Kenwood TS-930 Service Manual

Adjustment Procedures

Corrections, Notes, and Hints

VOLTAGE ADJUSTMENT

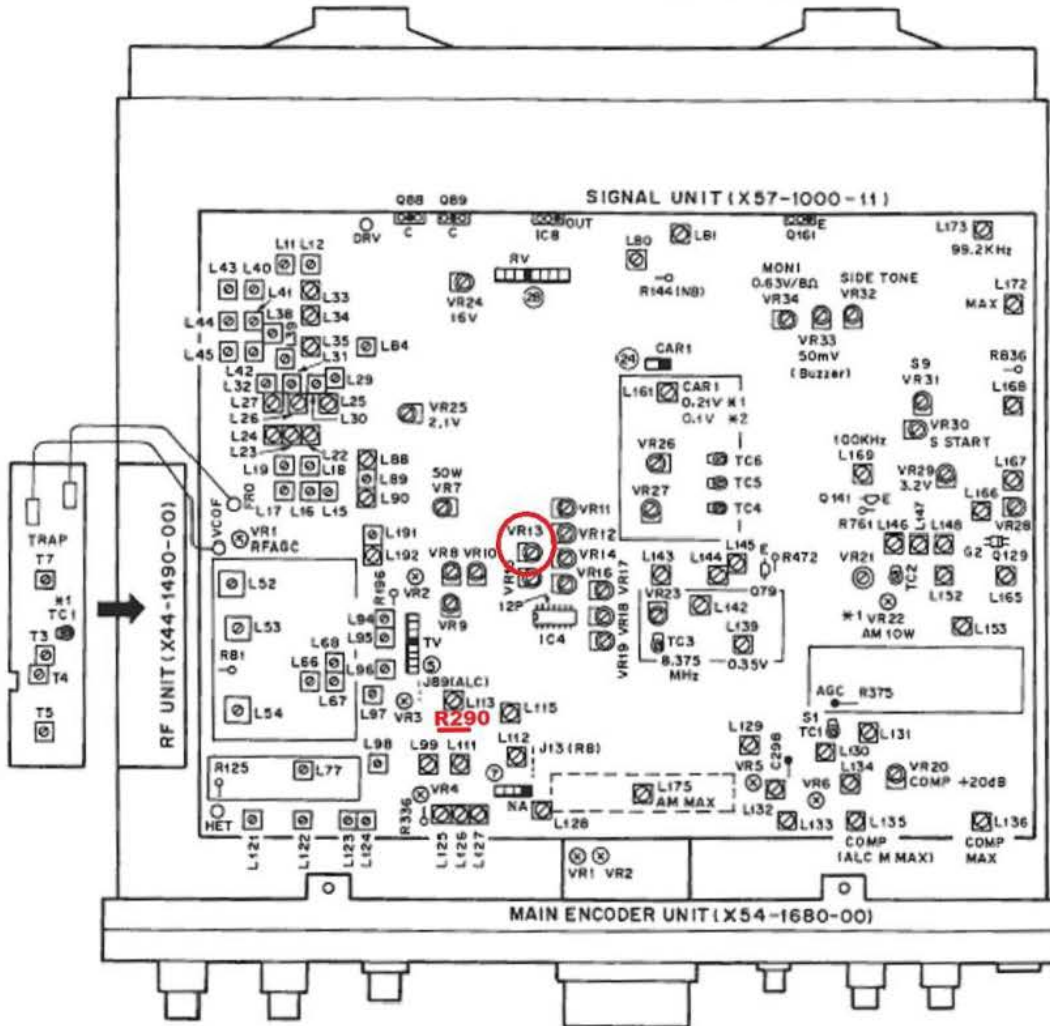
- Step 2 (3) specifies adjusting VR13 to set the TX Control Reference voltage to 3.20V (+/- .01V). The test point identified is Jumper J89.

Jumper J89 is the correct test point only on the Old Signal Unit. All of the Jumpers were renumbered on the New Signal Unit. In fact, this particular jumper no longer exists on the updated Signal Unit

- A better test point for this adjustment can be easily located on both models of the Signal Unit at R290, located just to the right and below VR3, the ALC adjustment pot, lower left quadrant of the SU looking from the front of the radio. See the following diagrams.
